**PREVOST**

**SAFETY  
RECALL**

Sr11-10

DATE : MARCH 2011	SECTION : 03-FUEL
SUBJECT : REPLACEMENT OF THE FUEL TANK SUPPORT

APPLICATION OF SELF-ADHESIVE NEOPRENE FOAM (dark area)

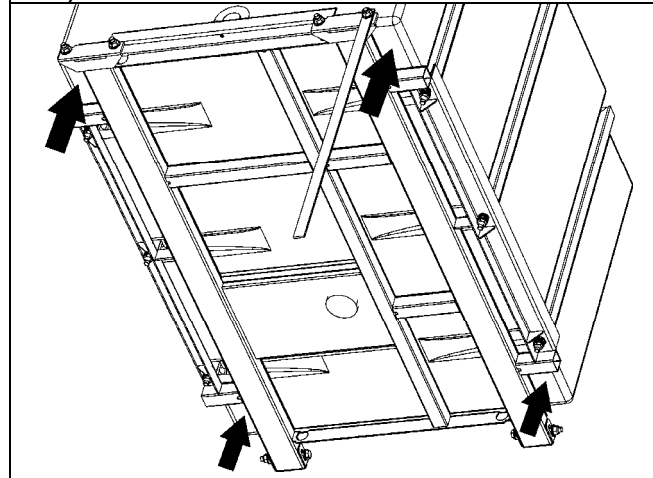
3. Apply self-adhesive neoprene foam (p/n 506758) on the new platform as shown.
4. Lift the vehicle.

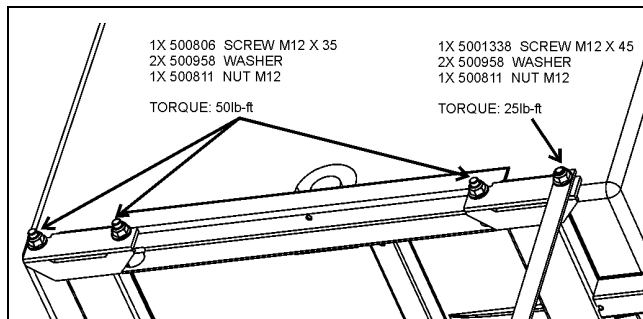
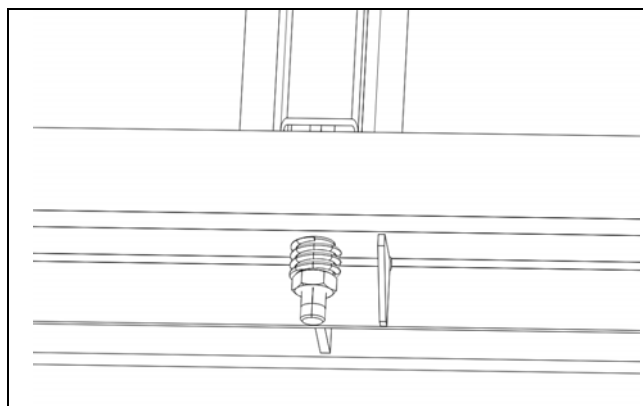
7. Unscrew the bolts (6) holding the fuel tank support to the vehicle chassis.
8. Replace the existing fuel tank support with the new one. Identify the defective support so it will not be reuse.
9. Install the new support with **new** bolts, washers and nuts.
  - Tighten bolts to 50 lb-ft (5 bolts)
  - Tighten bolts to 25 lb-ft (with static wick)

1X 500889 SCREW M12 X 120  
2X 500958 WASHER  
1X 500811 NUT M12

TORQUE: 50lb-ft

1X 500889 SCREW M12 X 120  
2X 500958 WASHER  
1X 500811 NUT M12

TORQUE: 50lb-ft
